## Discussion Points on HyTunnel CS Recommendation Report

### **HyTunnel Study Recommendation – *Limit the thermally activated pressure relief device (TPRD) orifice size on the vehicle’s hydrogen storage pressure vessels***

Figure 3-6. Contribution of hydrogen combustion to HRR in a passenger car fire (Okamoto et al., 2009). Example of hydrogen blowdown from 70 MPa, 62 L tank through TPRD of diameter 2 mm, 1 mm and 0.5 mm

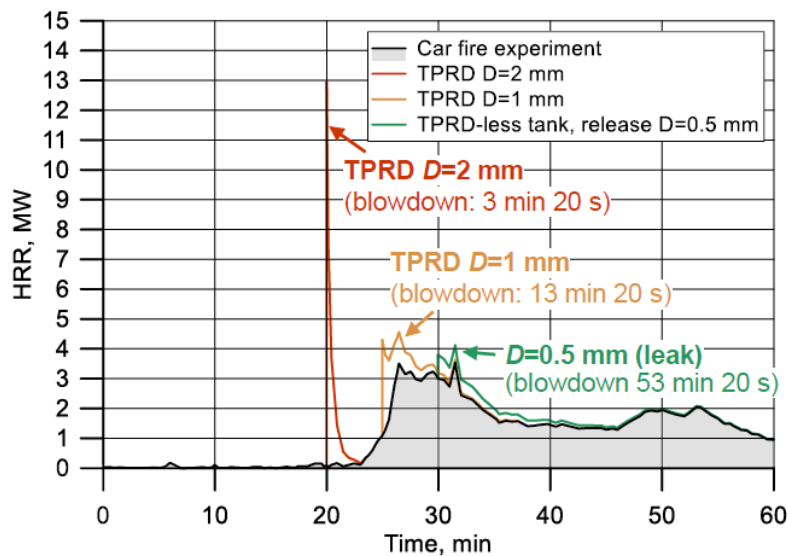
Another reason for the smaller TPRD recommendation was to minimize the contribution of the hydrogen to the heat release rate (HRR) during a car fire. Figure 3-6 in the report shows the HRR curve for the

range of TPRD orifice sizes as mimicking the shape of the HRR curve of the experimental car fire, while the HRR curve for the 2 mm orifice shows an accurate peak-shaped curve due to the tank blowdown. No explanation is given for the difference in curve shape (the HRR from any sized TPRDs will result in a peak-shaped curve) or the difference of the initiation timing. For example, it's unclear why the 1 mm orifice would activate approximately 5 minutes later than the 2 mm orifice, nor why the .5 mm is delayed a further 5 minutes. Accurate HRR curves, including the extended duration of the tank blowdown due to the smaller orifice size, need to be examined.
